NUMBER: 18-051-13
GROUP: Vehicle Performance
DATE: October 22, 2013

Flash: MIL Illumination P2073 or P2074 MAP/TPS, or P0400 EGR System, or P2279 - Intake Air System

Air Filter

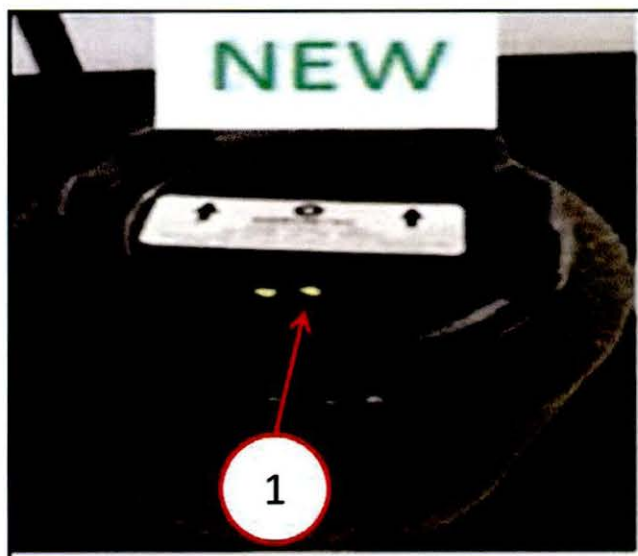
1. Replace the Air Filter with the latest MOPAR Certified Filter which has two certification dots as shown below ().

1- Two Certification Dots
